EM20-003

ITB20-002

2016-2019 Q50 AND 2017-2018 Q60; VR30DDTT ENGINE SERVICE INFORMATION

APPLIED VEHICLES:	2016-2019 Q50 (V37) 2017-2018 Q60 (CV37)
APPLIED DATE:	2016-2019 Q50 vehicles built before August 9, 2018 2016-2018 Q60 vehicles built before July 5, 2018
APPLIED ENGINE:	VR30DDTT (V6)

Figure 1

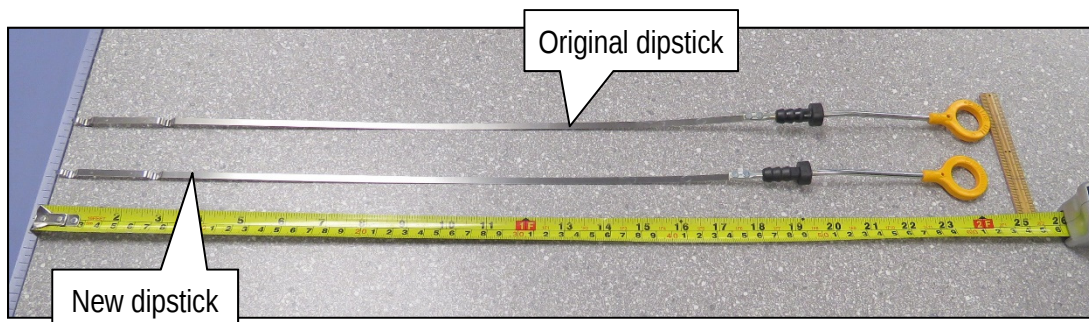
When replacing a VR30DDTT short block or long block in an applied vehicle for any reason, replace the dipstick with the part listed in **PARTS INFORMATION** on the next page. The length of the new dipstick is shorter so that it can accurately measure the new oil fill volume.

Figure 2

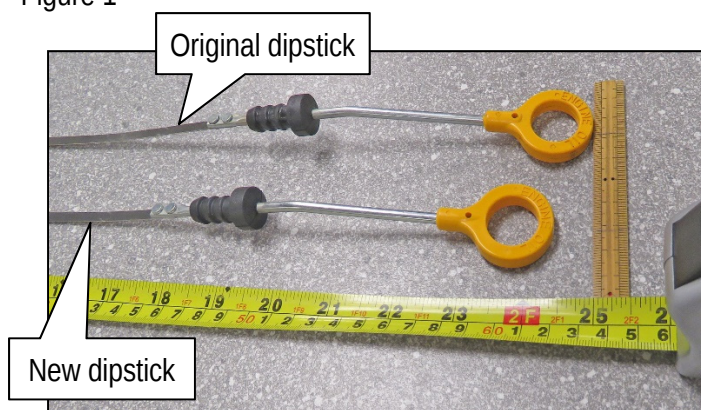
- If the overall length of the dipstick is approximately 25 inches (63.5 cm), replace the dipstick with the one listed in **PARTS INFORMATION** on the next page.
- The overall length of the new dipstick is approximately 24 ¼ inches (62 cm).
- The new dipstick reflects an increase in oil fill volume by 0.5 quarts (0.5 liters).
